ZONING CHANGE REVIEW SHEET

CASE: C814-2017-0001 – 425 W. Riverside PUD

ADDRESS: 425 W. Riverside Drive

ZONING FROM: CS-1-V-NP **TO:** PUD-NP

EXHIBIT C - LAND USE PLAN

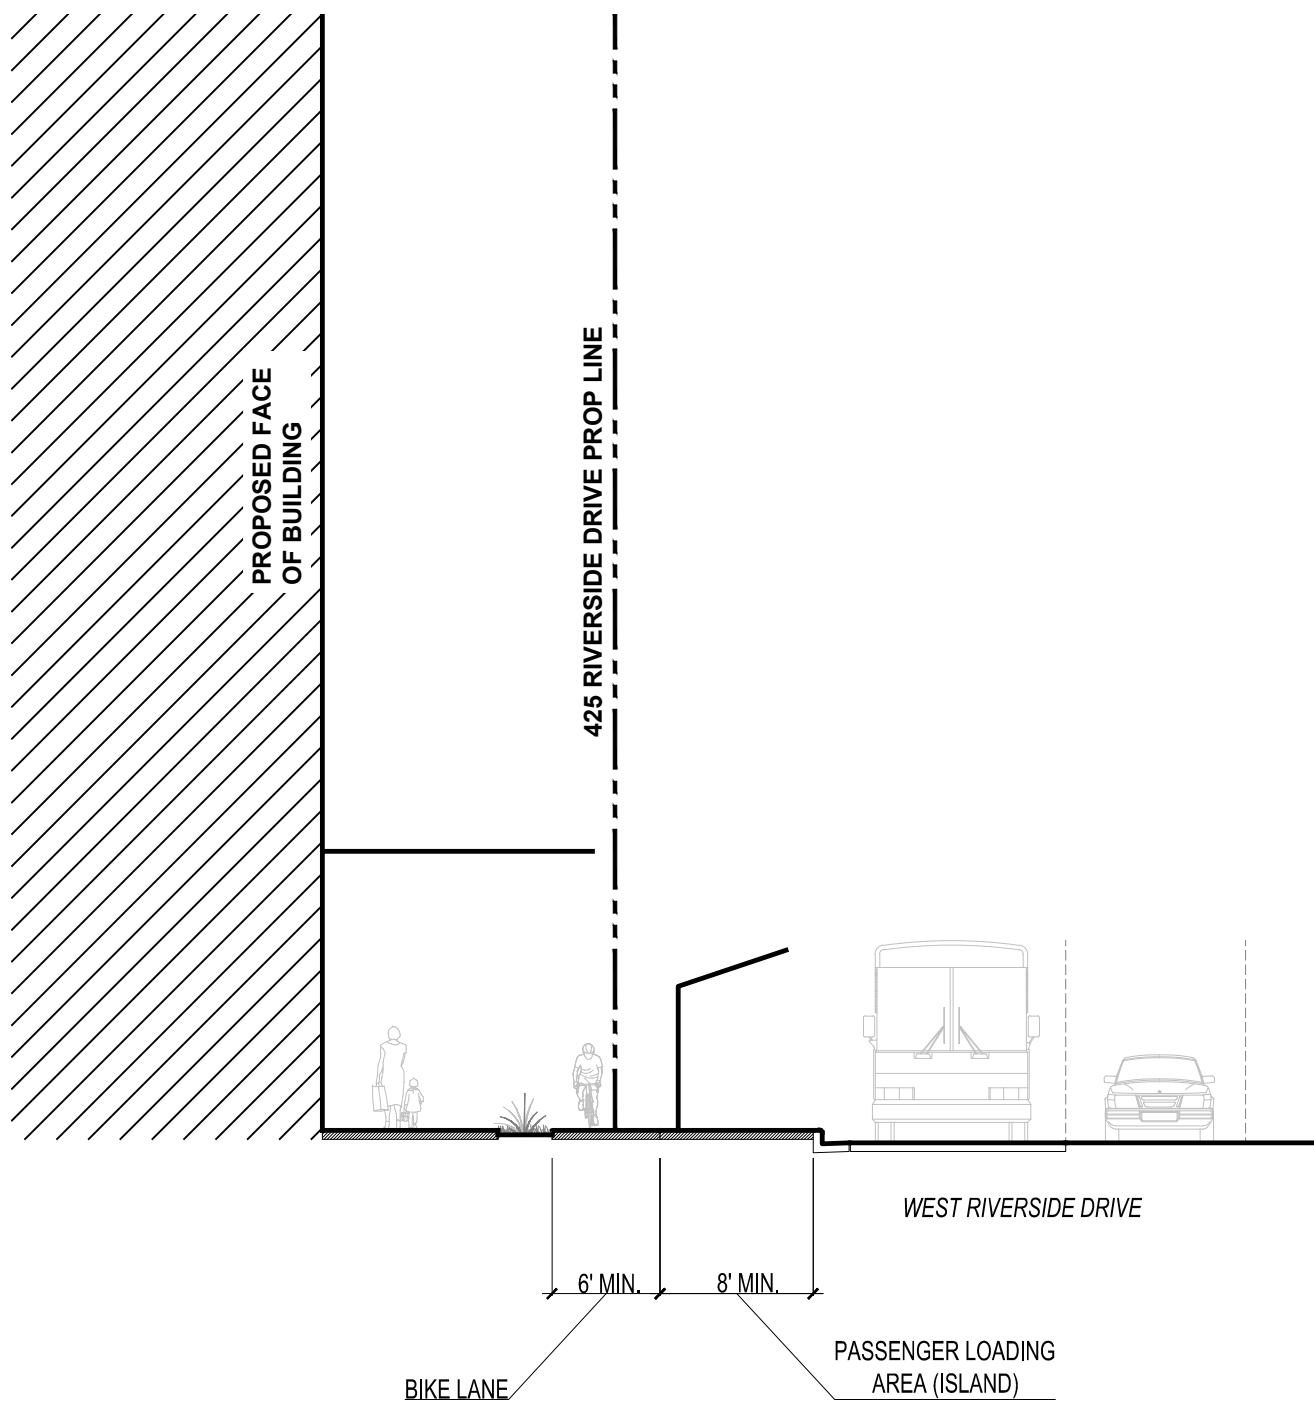
U1: Please identify the proposed open space areas on the land use plan and calculate the size of each area. Please provide additional details about the elevation and connectivity of the plaza areas. The open space should be accessible and identifiable as a public area; it should not be fragmented into a sidewalk level and a building entrance level with an elevation change, stairs, railing, etc.

U3: The proposed Open Spaces A, B, C, and D (green roof) are acceptable, as is the minimum commitment of 15% of the site. However, please prepare an open space exhibit that can be included with the PUD ordinance. (Something like the submitted exhibit can be used, but it currently says “for informational purposes only – Update 2”). This comment can be cleared informally.

- #1 Corner radiuses: I’m OK with the 25’ radius representation on the land use plan – Exhibit C under the assumption that these show effective radiuses and that details of ADA ramp and bikeway configurations and actual curb radiuses will be decided at site plan (while conforming to the effective radius.

- #2 On exhibit C, note 4 should be removed. In the above comment we need to retain the ability to design the corners and bikeway interactions at site plan. A single curb ramp is not preferred from an pedestrian / bicycle design and may not align with ADA requirement / best practices.

425 WEST RIVERSIDE DRIVE
AUSTIN, TRAVIS COUNTY, TEXAS
EXHIBIT E - STREET CROSS-SECTIONS

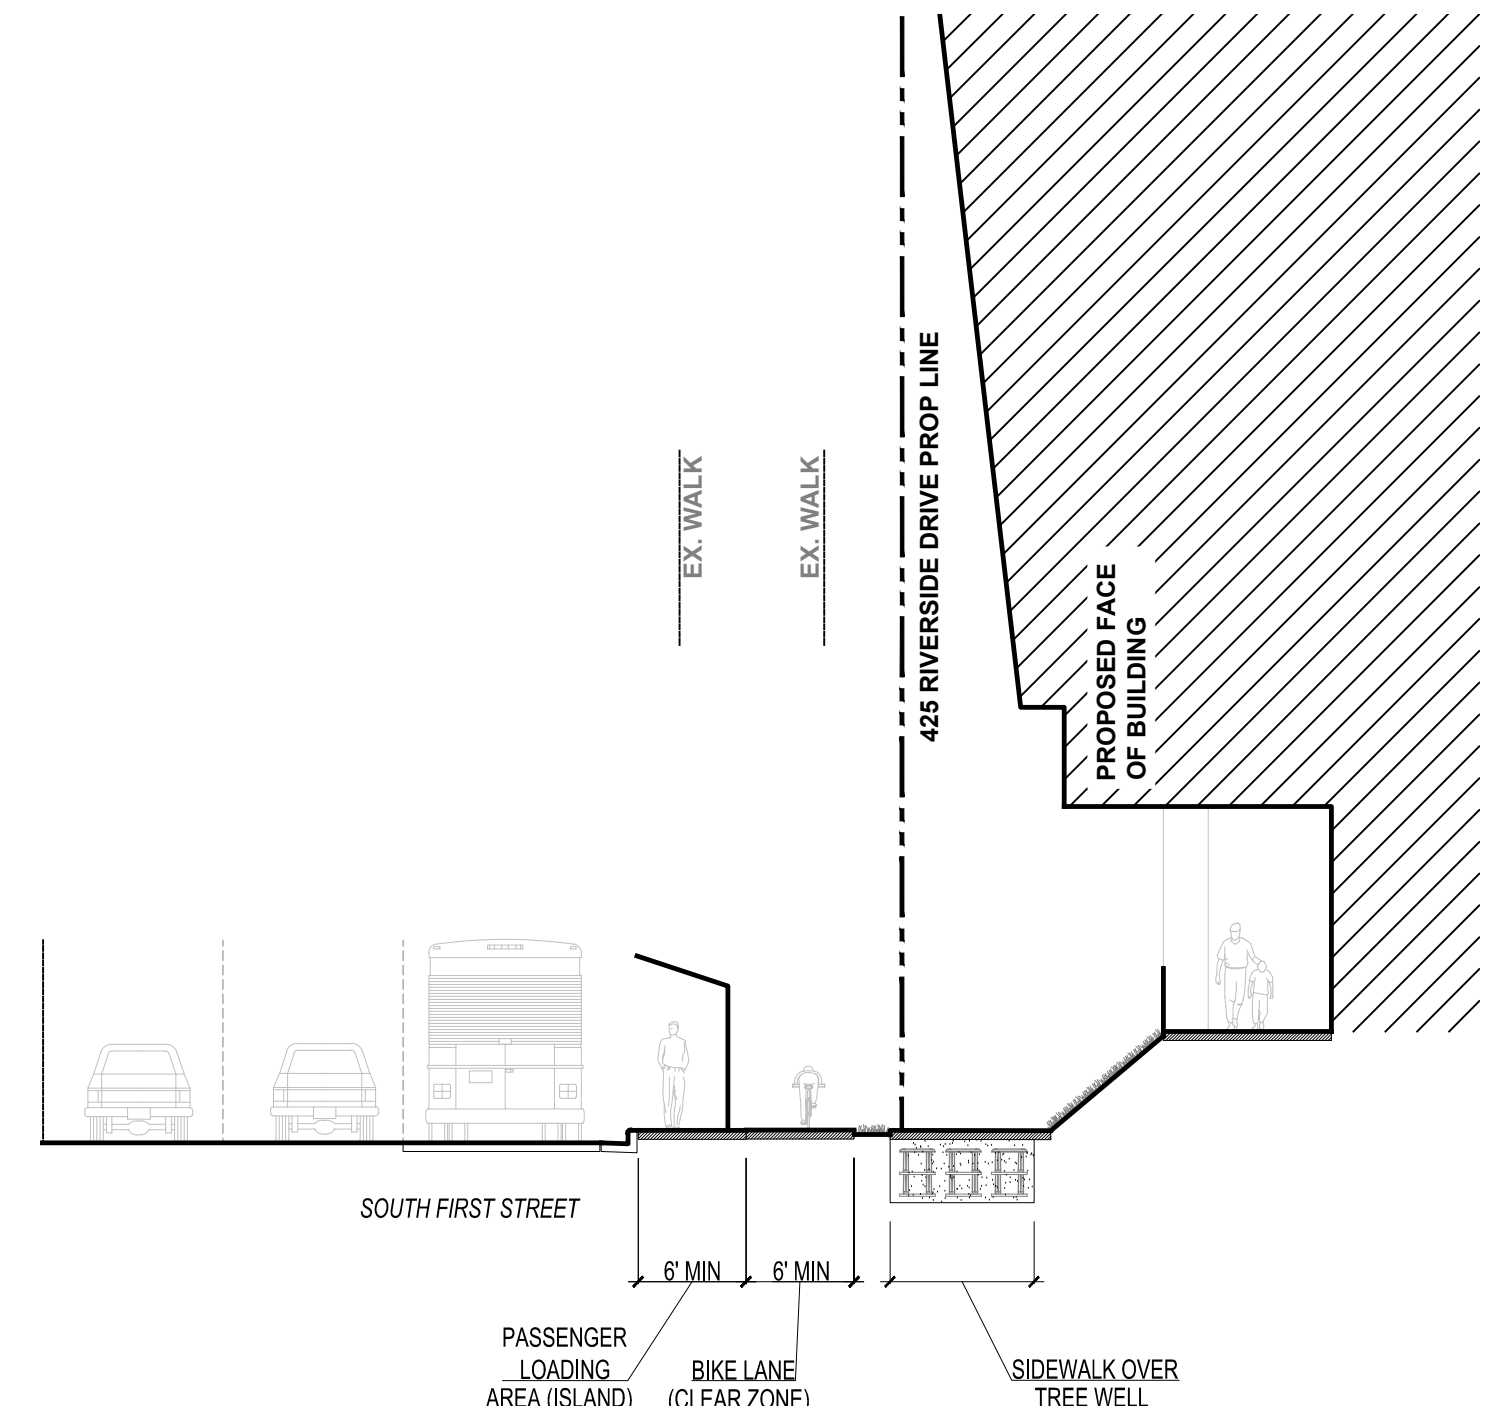
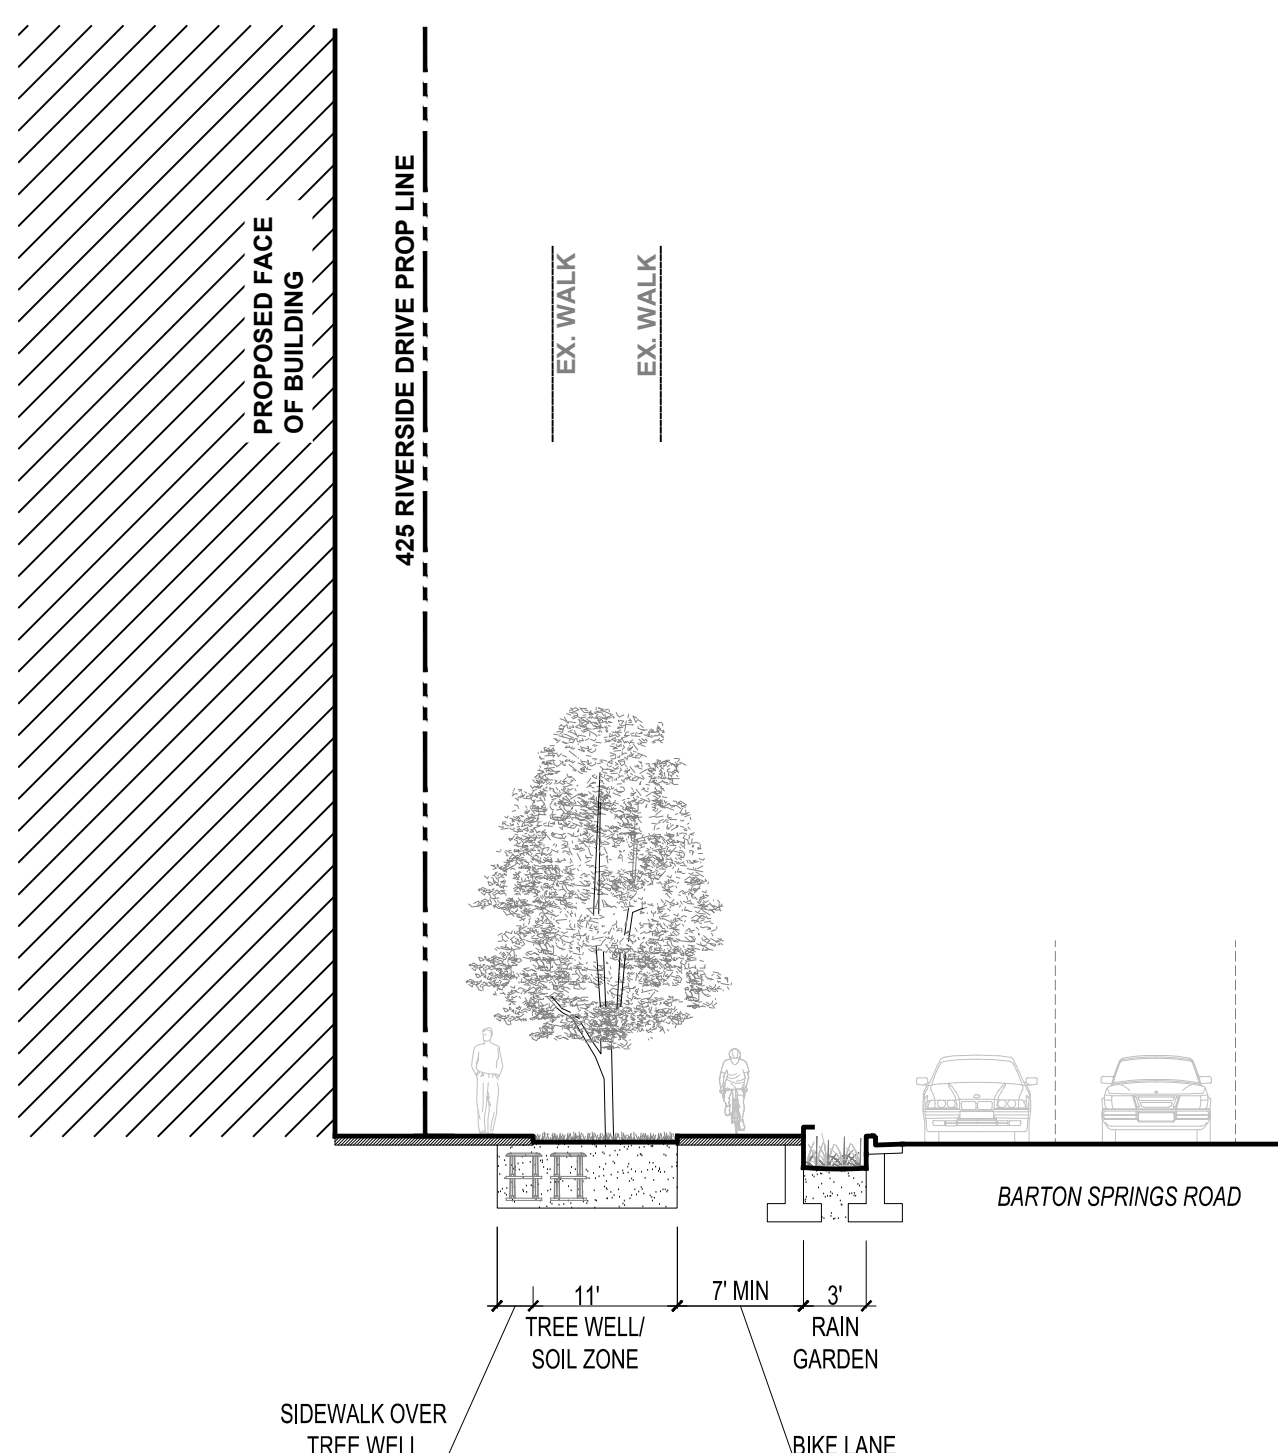
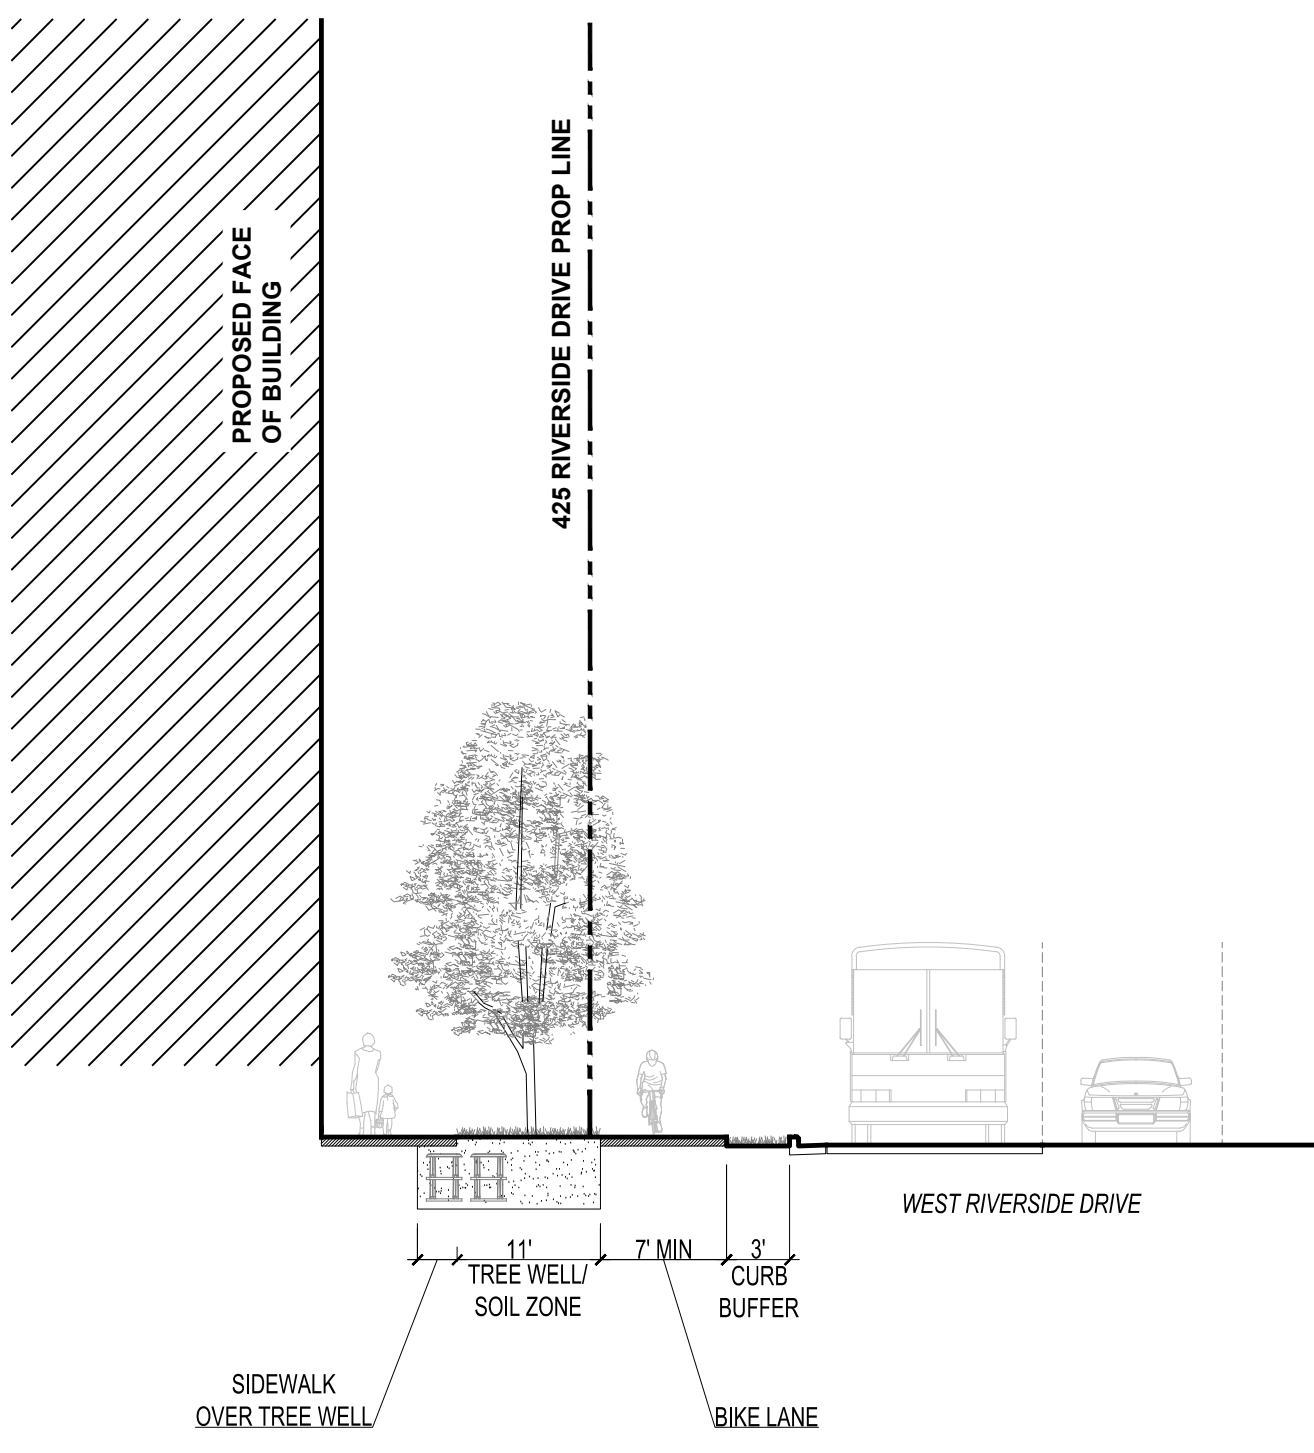
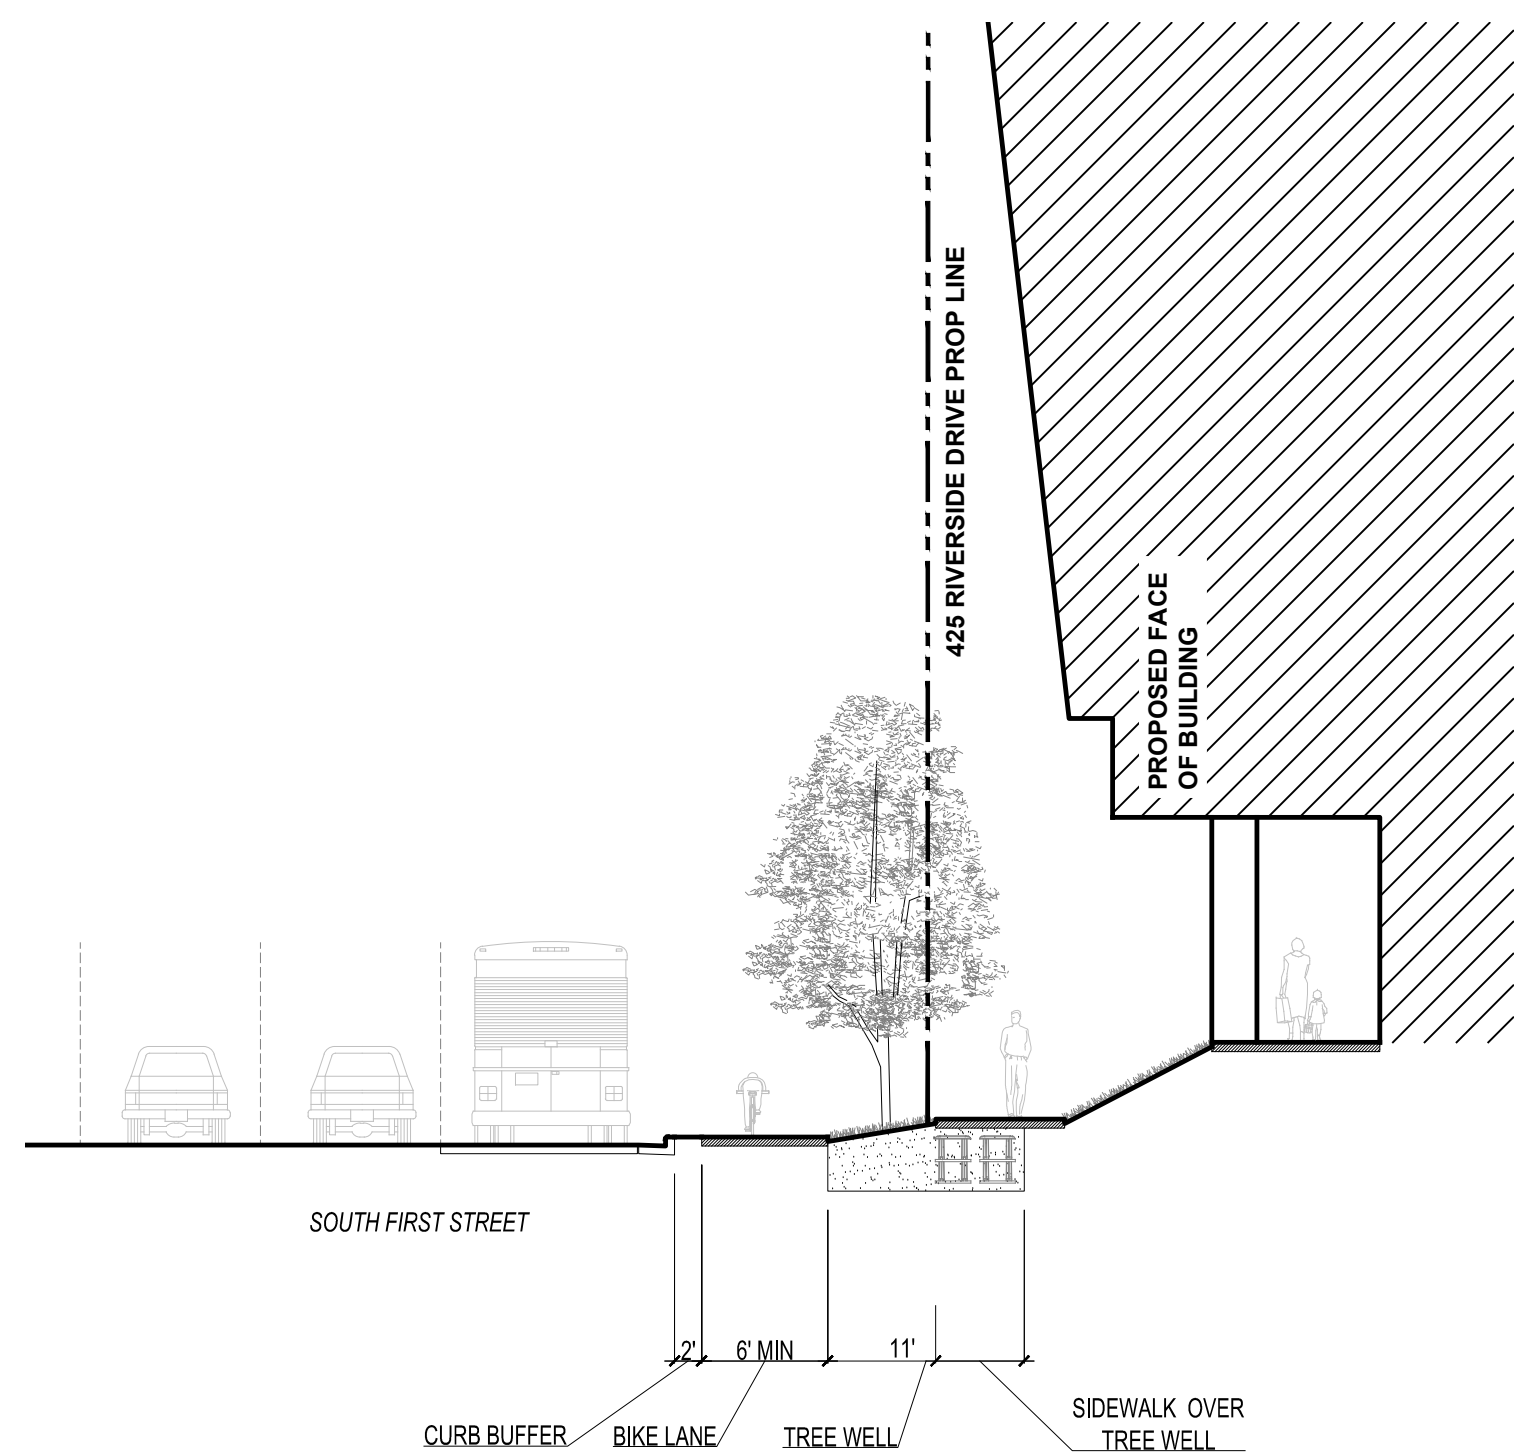
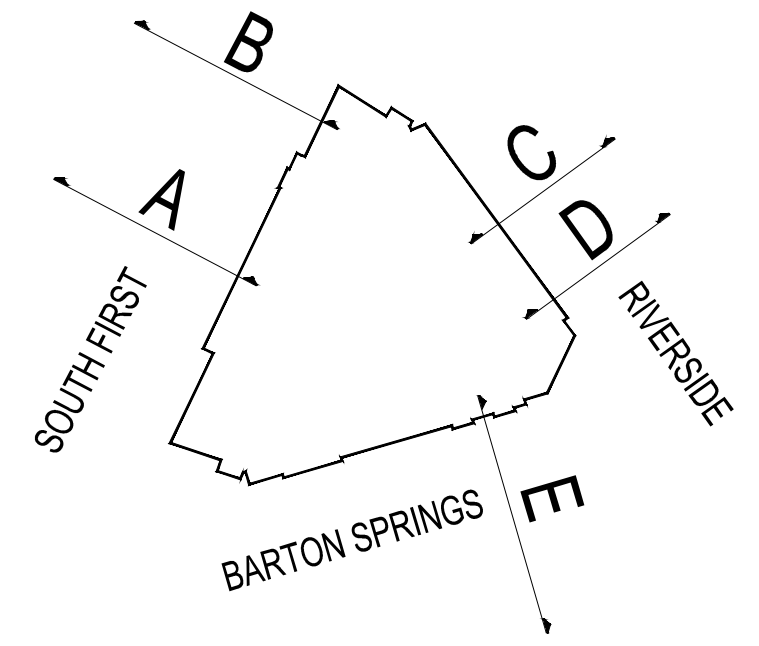
- #3 Bicycle Lane Width - the bicycle lane widths do not conform to the original drawing I sent in May. In the attached Exhibit C and E I have marked up width changes. In short the following are the dimensional requirements for the bicycle lane in a few scenarios:
If pavement on either side of bicycle lane is not rideable than 7' is the minimum bikeway dimension.

If there is a dropoff into a rain garden there needs to be a hand rail that is recessed from the bike lane by 6" as to not encroach in the bicycle lane space (handrails should be added to relevant cross sections in exhibit E. If there is rideable pavement on both sides of the bike lane the minimum acceptable dimension is 6'

Update #2 – Provide an exhibit with dimensions for the driveway lanes which show that a 25ft unobstructed pavement width is proposed. The 2ft bike curb buffer should not be included in the width, since AFD will not drive on/over the buffer. Also, provide a full size scaled drawing showing the streets and turning radii so that AFD can verify that turns can be made without driving into oncoming traffic.
